# UNITED STATES PATENT AND TRADEMARK OFFICE

10/533,550

**Office Action Summary**

## **DETAILED ACTION**

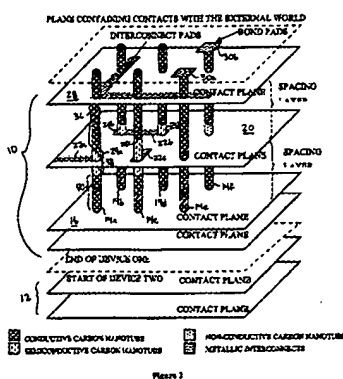
6. As for claims 22 and 41 – 42, Mancevski discloses (Page 3 [0040]) and shows in

Fig. 2 a carbon nanotube transistor comprising:

- a. a first electrically conductive layer (16);
- b. a middle layer /spacing layers(10), formed partially from dielectric material, on the first electrically conductive layer;

- c. a second electrically conductive layer on the middle layer (28), and;
- d. a nanostructure (14) integrated in a via hole/vertically aligned holes introduced into the middle layer, the nanostructure further comprising a first end portion that is coupled to the first electrically conductive layer and a second end portion that is coupled to the second electrically conductive layer (as shown in the Fig, 2 both ends of the nanotubes are imbedded in the contact layer);

- e. wherein the middle layer, between two adjacent dielectric sublayers/spacing layers, has a third electrically conductive layer (20), the thickness of which is less than the thickness of at least one of the dielectric sublayers (as shown in Fig 2, the contact plane is thinner than the spacing layers).

9. As for claims 24 – 25, Mancevski shows in Fig. 2 that the third conductive layer/contact layer (20) surrounds the nanostructure in the middle of the transistor as well as it been thinner than both dielectric layer/spacing layers.

16. As for claim 26, Mancevski discloses (Page 8 [0102]) and shows in Fig. 2 that the construction of the nanostructure includes both ends as source and drain regions. It further discloses the middle part includes a gate electrode.

19. As for claim 28, Mancevski shows in Fig. 2 that creation of a second transistor (12) next to the original transistor (10).

Fig. 1

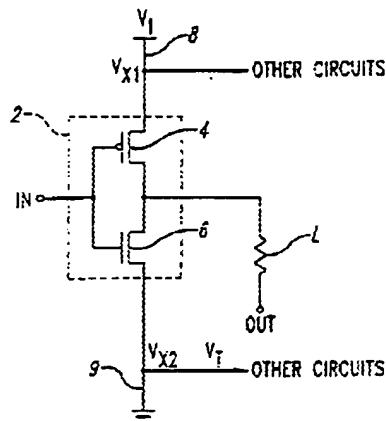
**25. Claim 29 rejected under 35 U.S.C. 103(a) as being unpatentable over Mancevski in view of Martin et al. US 2001/0019279 (Martin).**
